State of New Mexico
Energy, Minerals and Natural Resources Department

SUNDRY NOTICES AND REPORTS ON WELLS

APACHE HILLS #3

PLUG AND ABANDONMENT PROCEDURE

Proposed P&A

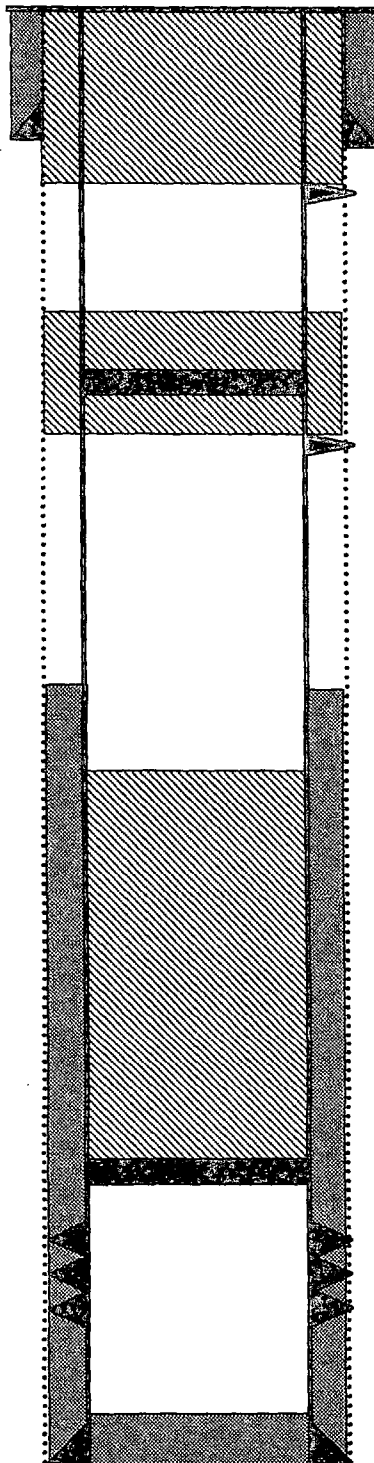
3. **Plug #1 (Pictured Cliffs interval, Fruitland, Kirtland and Ojo Alamo tops, 3272' – ²⁹⁸⁶2840')**: PU and TIH with 4.5" cement retainer, set at 3272'. Pressure test tubing to 1000 PSI. *Pressure test casing to 800 PSI. If casing does not test, then spot or tag subsequent plug as appropriate.* Mix and pump ~~27~~ sxs Class B cement above CR to isolate the Pictured Cliffs interval and cover the Fruitland and Ojo Alamo tops. PUH.

4. **Plug #2 (Nacimiento top, ¹⁶⁹⁸1356' – ¹⁵⁹⁸1256')**: Perforate squeeze holes at ¹⁶⁹⁸1356'. Attempt to establish rate if the casing pressure tested. Set 4.5" cement retainer at ¹⁶⁹⁸1306'. Establish rate into squeeze holes. Mix and pump 51 sxs Class B cement, squeeze 39 sxs outside 4.5" casing and leave 12 sxs inside casing to cover the Nacimiento top. TOH and LD tubing.

Provide CBL to agencies for review prior to cementing
